2758 PRINCE EDWARD (COMPLETE APPLICATION)
DE410898 - ZONE C-3A

DEVELOPMENT PERMIT STAFF COMMITTEE MEMBERS

DEVELOPMENT PERMIT STAFF COMMITTEE RECOMMENDATION: APPROVE

Figure 1

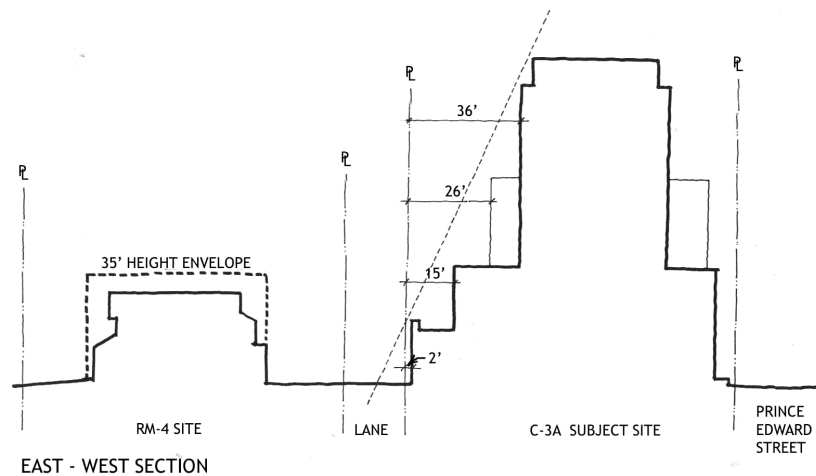
The first review by the Urban Design Panel identified upper massing issues. The Panel recommended a more compatible transition in scale with the lower height RM-4/RM-4N neighbours and an improved urban response to the overall fit within the broader urban context. The Panel cited the neighbouring hotel (7 storeys and 84 ft.) with its longer, thinner, "slab" building form as a more appropriate response for this site. The "Stella", on the west side of Kingsway currently under construction, is likewise of a similar building form.

In response to these concerns, the upper massing was revised and redistributed into a longer, thinner, "slab" form, which is proportionally more compatible with the massing of the adjacent hotel. This form also provides substantial setbacks from the adjacent RM-4 neighbours. Figure 1, below, illustrates the significant shaping of the building massing adjacent to the RM-4/RM-4N neighbours to the east. Similar stepping of the massing has also occurred along the 11th Avenue frontage. Mid-day shadowing during the Spring and Fall equinox has minimal impact on the adjacent RM-4/RM-4N sites. (See

Appendix D, page 6 of 34) The Urban Design Panel agreed the revised scheme had resolved the issues of compatible scale and urban form well. (see UDP minutes, page 14)
